CALIFORNIA COASTAL COMMISSION

SUBJECT: Revised Findings for UCSB Long Range Development Plan (LRDP) Amendment 1-04 and Notice of Impending Development (NOID) 2-04, for the San Clemente Housing Project, for Public Hearing and Commission Action at the September 2005, Commission Meeting in Eureka.

COMMISSION DECISION: STB-MAJ-1-04 Certified with Suggested Modifications; NOID 2-04 Approved with Conditions

Exhibit 6b

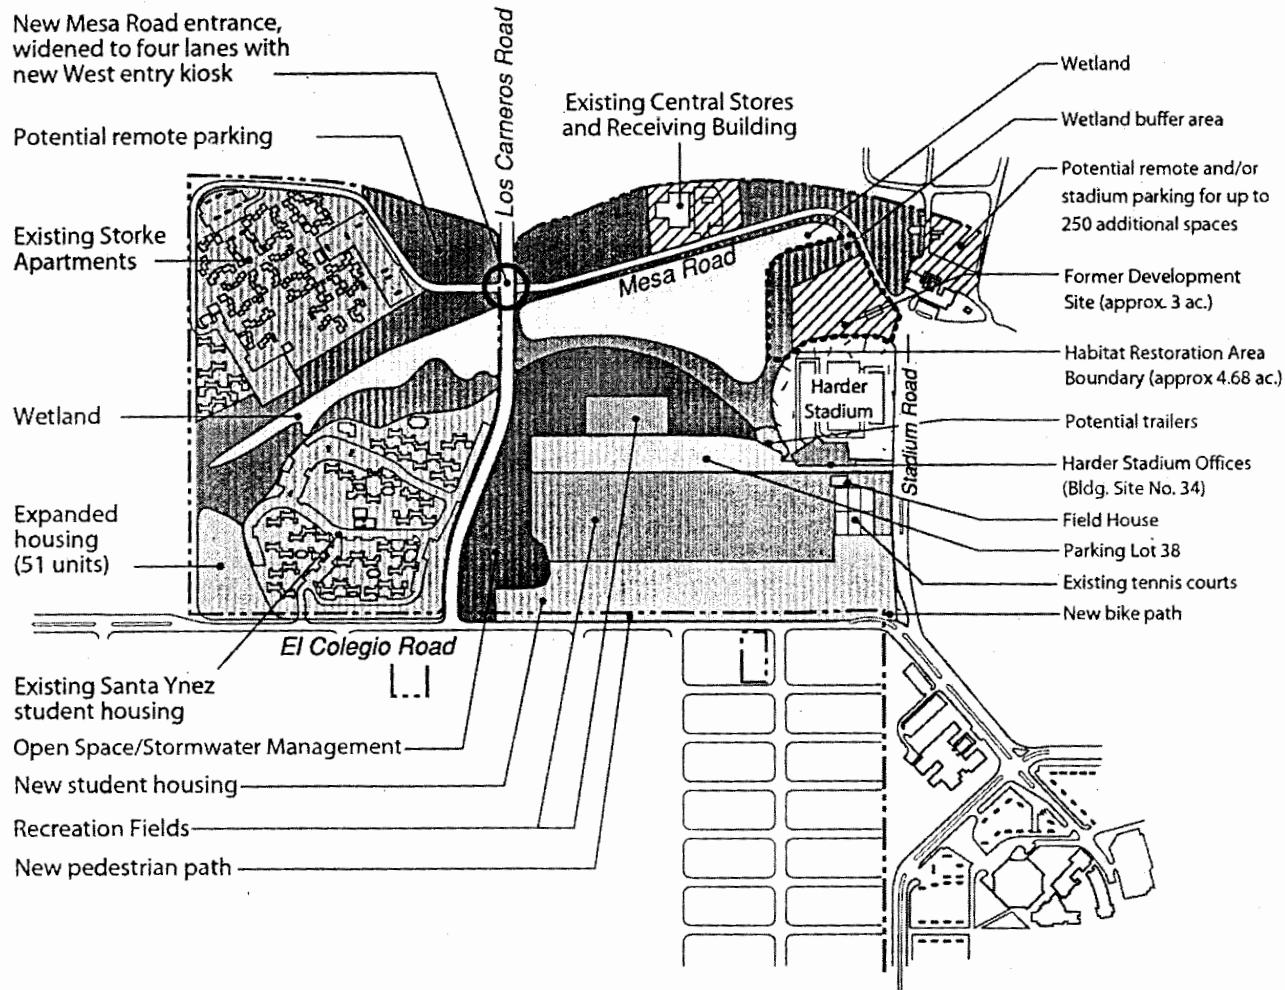
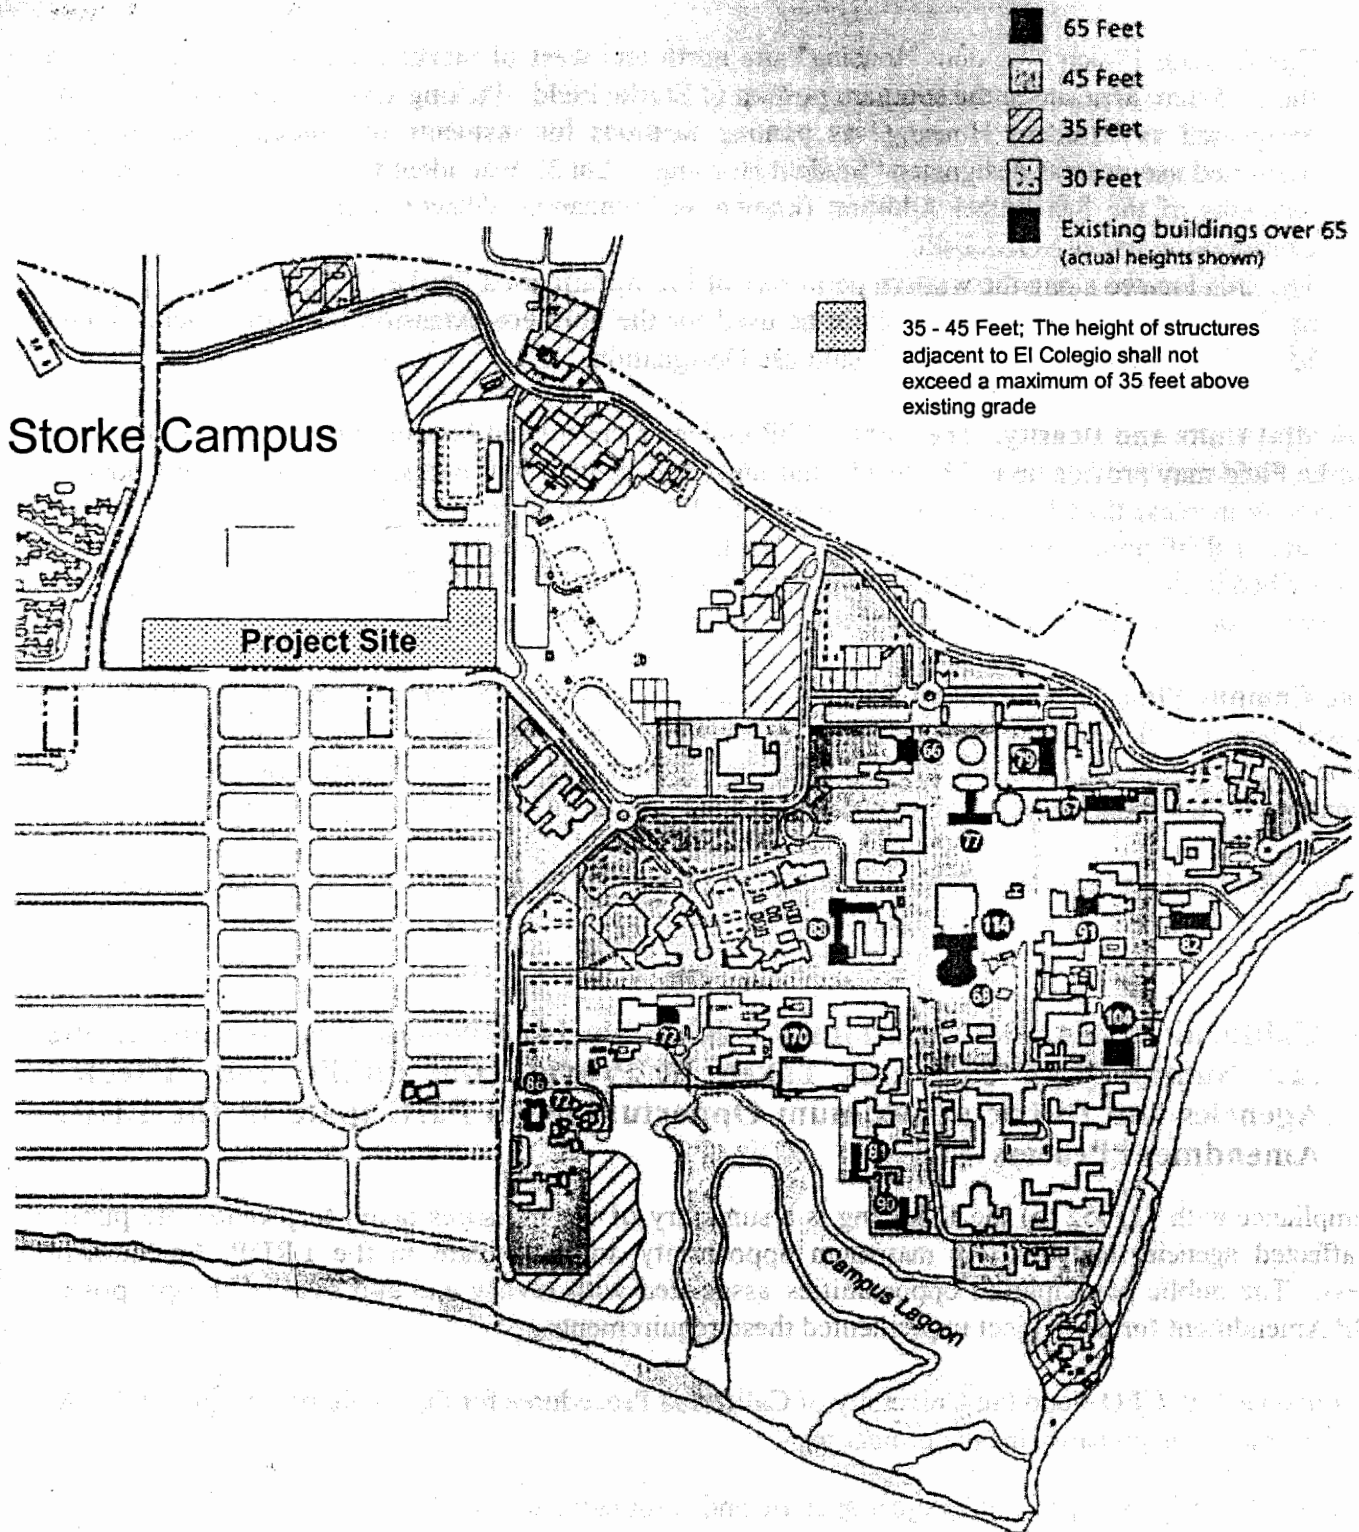
Figure 10 Land Use and Circulation, Figure 16 Campus Building Height Limits, and Figure 23 Storke Campus Plan of the certified Long Range Development Plan shall retain the certified land use designation (housing) and associated height limit in the area of the proposed athletic field north of Parking Lot #38.

Specifically, the proposed amendment modifies Figure 10 *Land Use and Circulation* (Exhibit 4), Figure 16 *Campus Building Height Limits* (Exhibit 5), and Figure 23 *Storke Campus Plan* (Exhibit 6) of the certified Long Range Development Plan to reflect the revised configuration of the housing site and design of the San Clemente Housing Project. Additionally, the amendment makes text amendments to all references within the 1990 LRDP regarding the number of residential units and bed spaces. The certified LRDP indicates that the student housing site adjacent to Storke Field may provide up to 281 residential units and contain 900 bed spaces. All such references shall be modified to represent the 315-unit and 976-bed space project proposed.

Exhibit 7
LRDPA 1-04 & NOID 2-04
Modified Height Limit

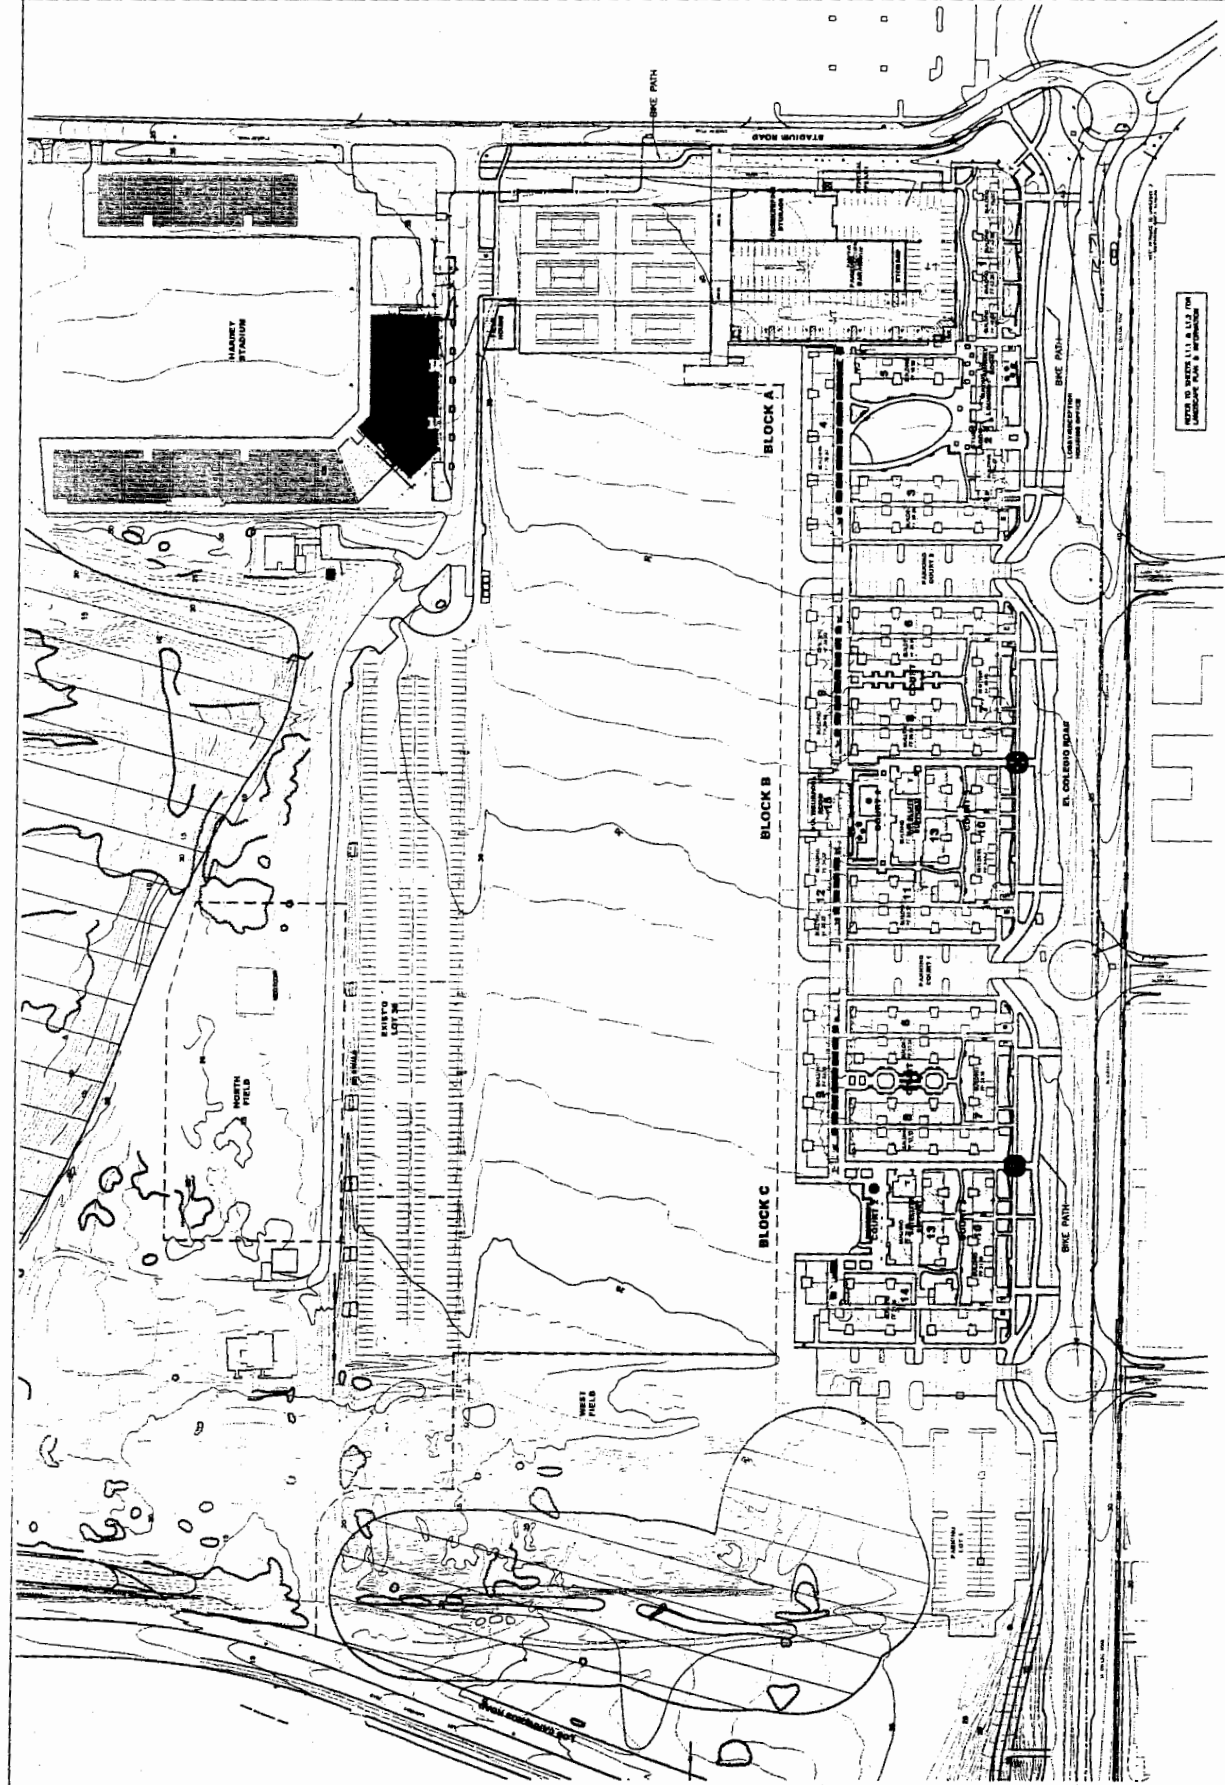
Figure 16, *Campus Building Height Limits*, shall be modified to show a maximum building height of 35-45 feet above existing grade, in the location of the housing development as shown in Exhibit 7 of this staff report. The exhibit shall specify that structures adjacent to El Colegio shall not exceed 35 feet above existing grade. The height may gradually increase to a maximum of 45 feet above existing grade as it approaches Storke Field. Parking structures shall not exceed 35 feet in height.

As provided in Section V.C, *Amendment Consistency*, of this report, the Commission has determined that the LRDP amendment is only consistent with the Coastal Act if Figure 16 of the LRDP is modified to designate the proposed housing site with a maximum building height of 35 to 45 feet, with all structures/buildings aligning El Colegio Road having a maximum 35 feet above existing grade and all structures/buildings aligning Storke Field to the north having a maximum 45 feet above existing grade as required by Suggested Modification Three. The policies of the LRDP indicate that buildings shall not exceed the height limits established in Figure 16.

Exhibit 15
LRDPA 1-04 & NOID 2-04
Wetland & Tarplant ESHA

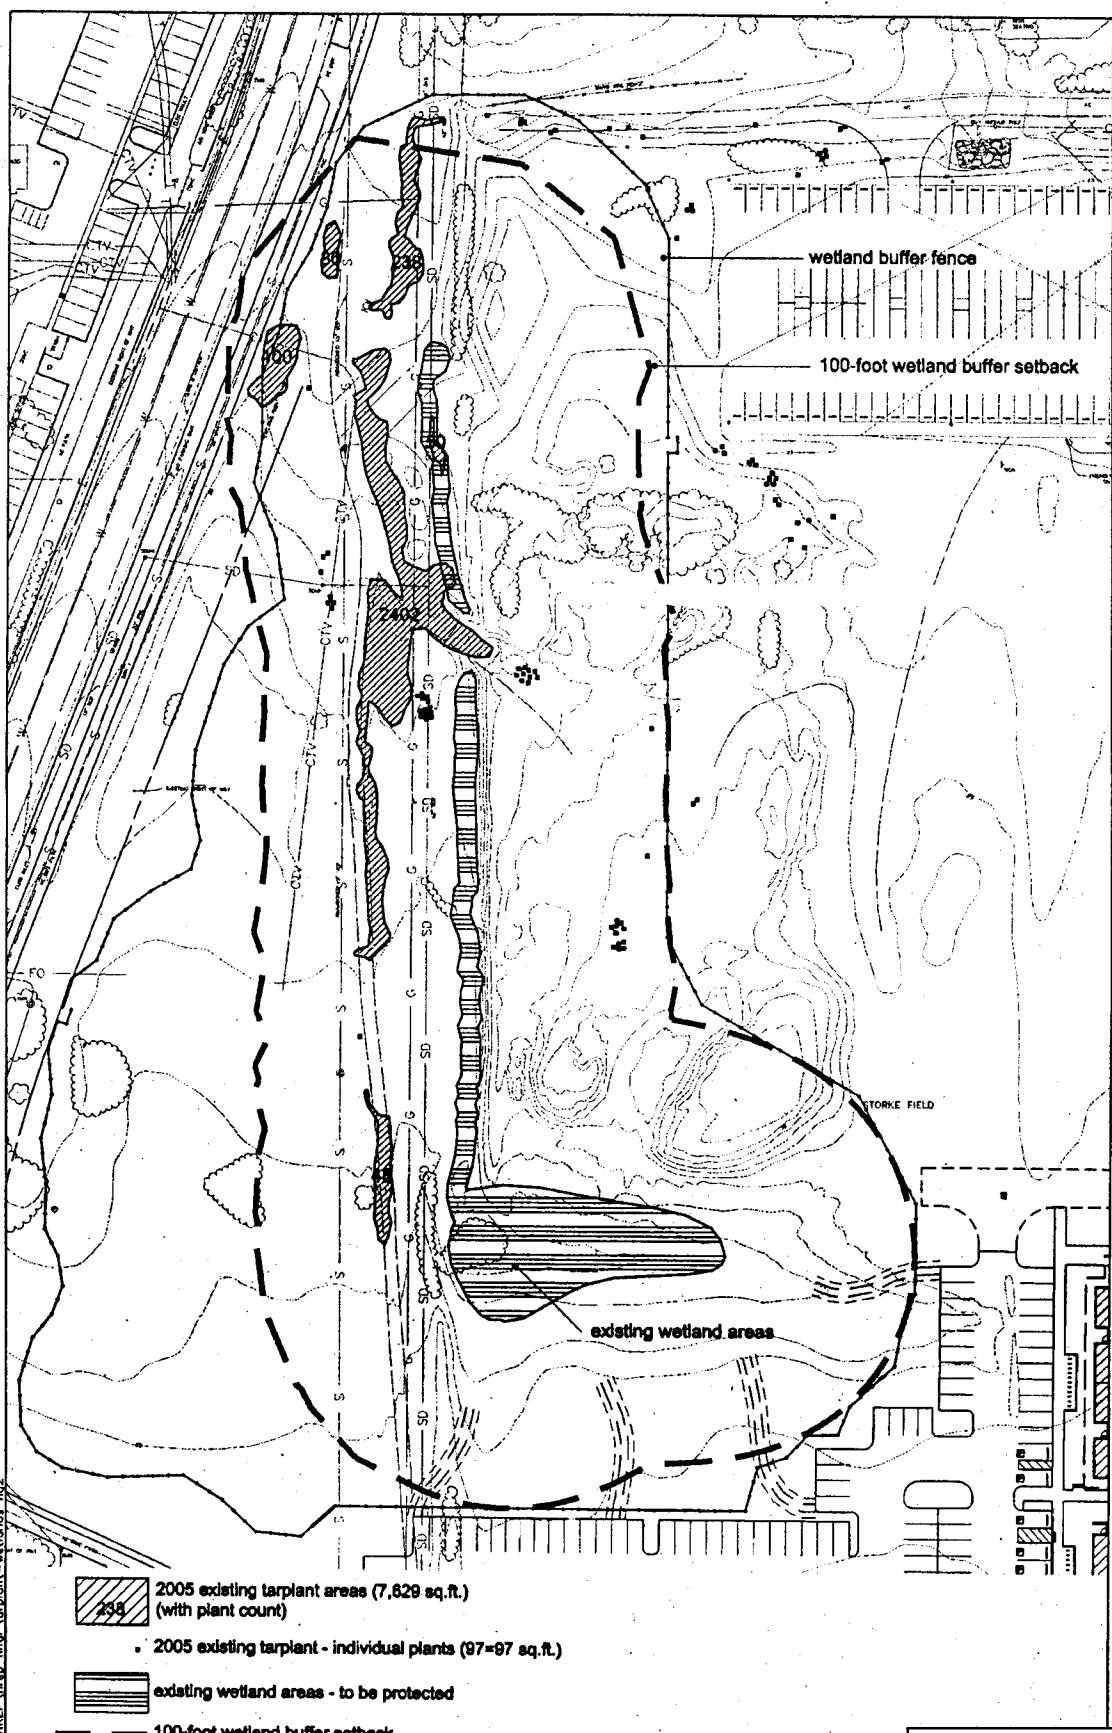
Figure 28, *Environmentally Sensitive Habitat*, shall be modified to designate the wetlands and southern tarplant areas as ESHA consistent with Exhibit 15 of this staff report.

Southern tarplant has been identified in the project area between Storke Field and Los Carneros Road. Six large areas of tarplant were mapped by the Morro Group during a May 2005 survey (Exhibit 15). The largest contiguous area was estimated to have 2,402 individuals. The other five areas were estimated to have between 30 and 238 individuals. Additionally, the survey identified several scattered areas of individual tarplants, located away from the main concentrations of tarplant. Due to the rare and sensitive nature of this species, in combination with the density and distribution of the population, the six contiguous areas of tarplant were determined to be environmentally sensitive habitat areas by the Commission's biologist. However, the scattered individual plants do not constitute ESHA.

Exhibit 16
LRDPA 1-04 & NOID 2-04
Revised Bioswale Design

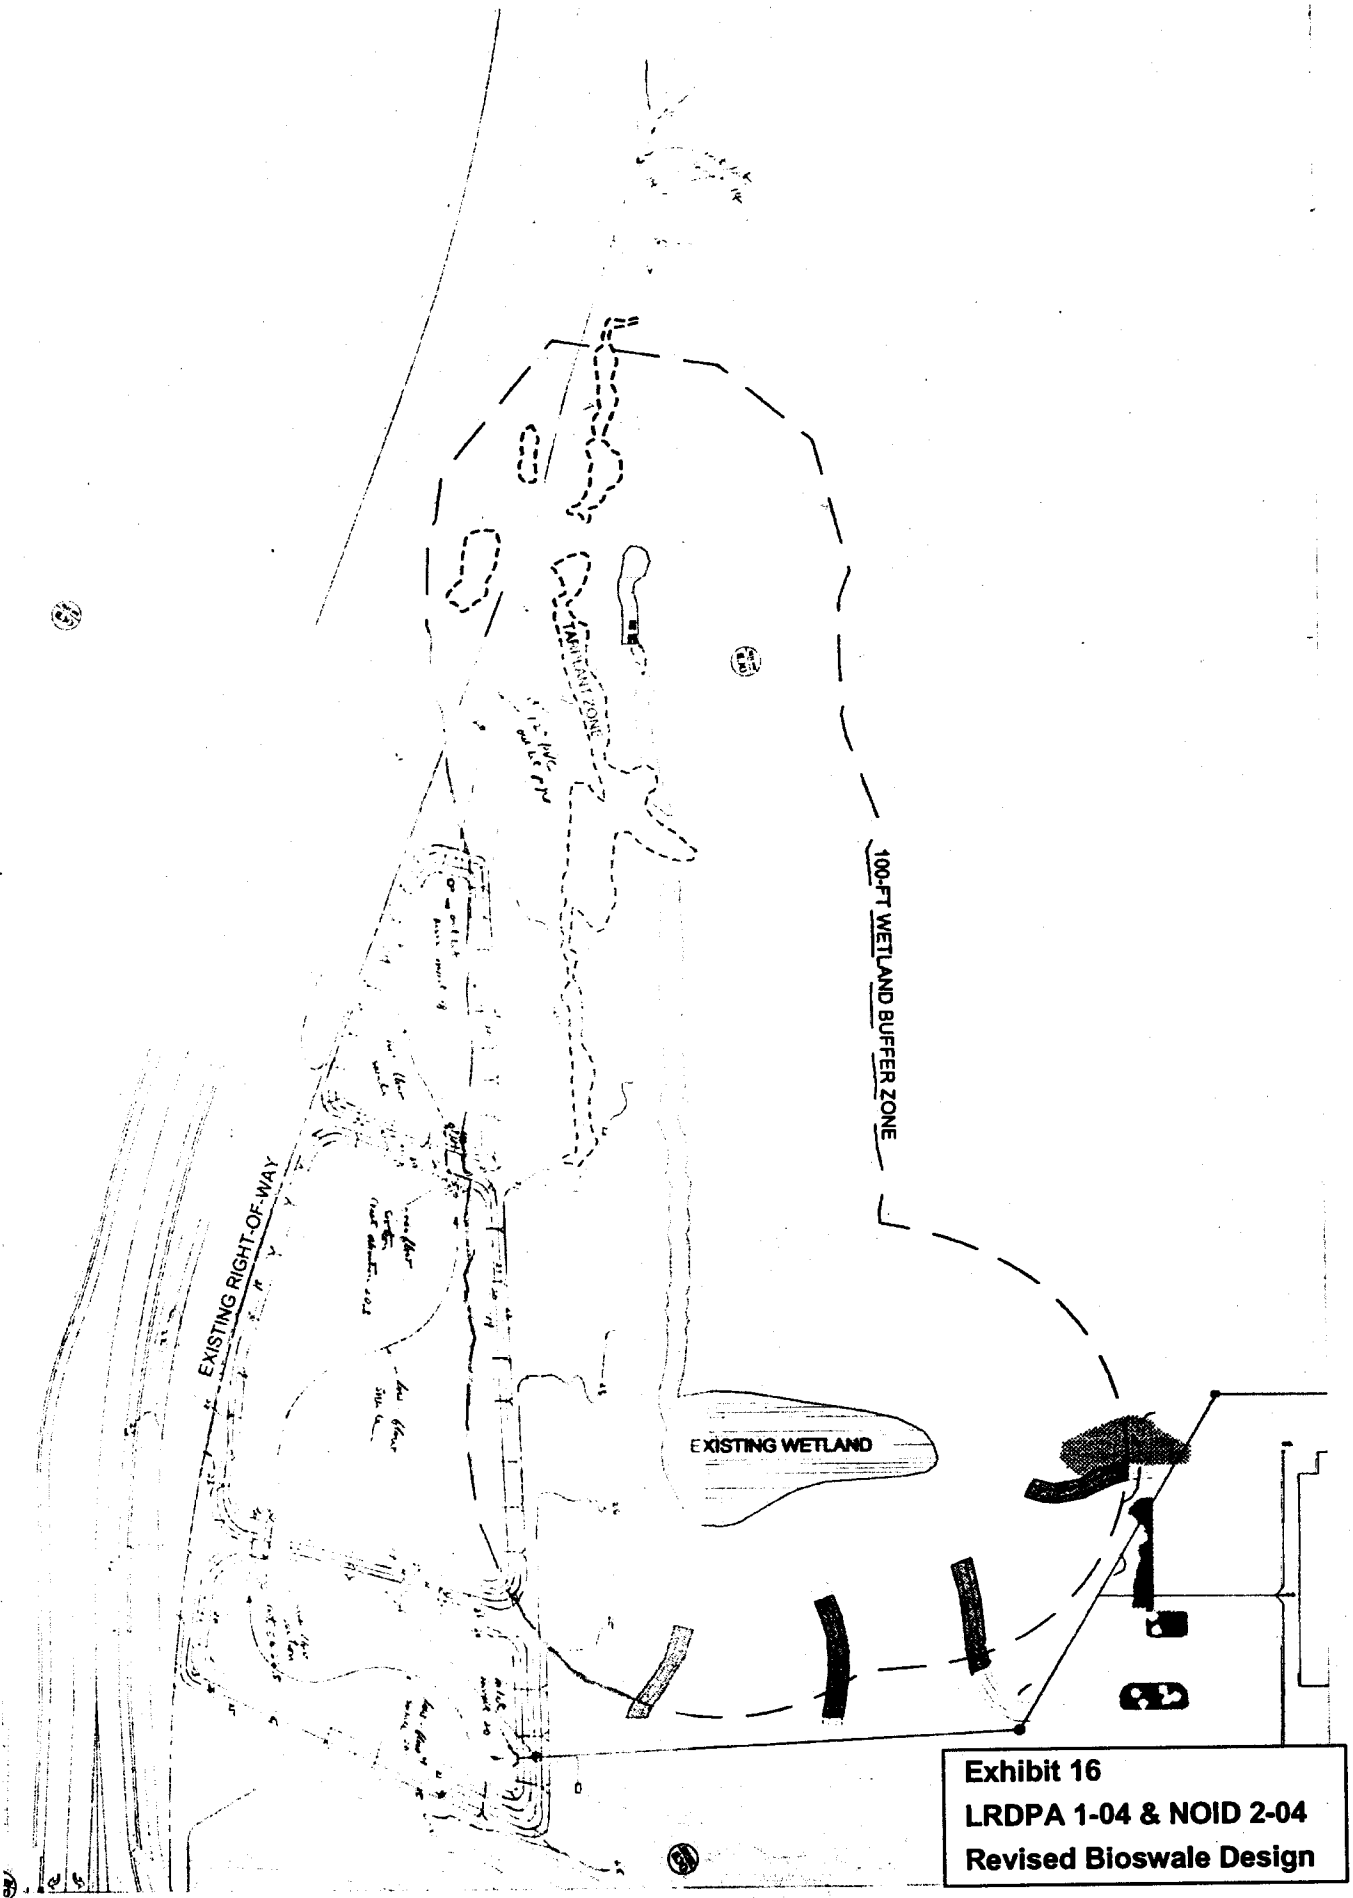
As proposed, the stormwater management system basins would be constructed partially within the 100-foot buffer of delineated wetlands (Exhibit 16). As originally proposed, approximately 1.1 acres of wetland buffer (approximately 47,000 sq. ft.) would have been disturbed as a result of this project. However, at staff's request, the University has submitted a revised conceptual plan to reconfigure the stormwater management system to minimize the footprint of the stormwater management system basins within the 100-foot wetland buffer to the maximum extent feasible. The new system would have the same capacity but would be more linear, and the previously proposed berms separating the bicycle path from the area would be eliminated. As revised, the stormwater basins would be setback a minimum of 65 to 80 feet from the delineated wetlands and would only occupy approximately 9,000 sq. ft. of the buffer area.

- (1) Final plans for the stormwater management system in substantial conformance with conceptual plans dated June 14, 2005.
- (2) The pedestrian path proposed between the wetland areas shall be rerouted to avoid wetlands and tarplant, as shown in Exhibit 18. Construction of the trail shall be limited to a three- to four-foot compacted soil path. Alternately the trail may be constructed of Class 2 road material, and decomposed granite shall not be used. The trail shall be demarcated by a low-profile, maximum 42-inch high, post and cable or other open fencing, acceptable to the Executive Director.
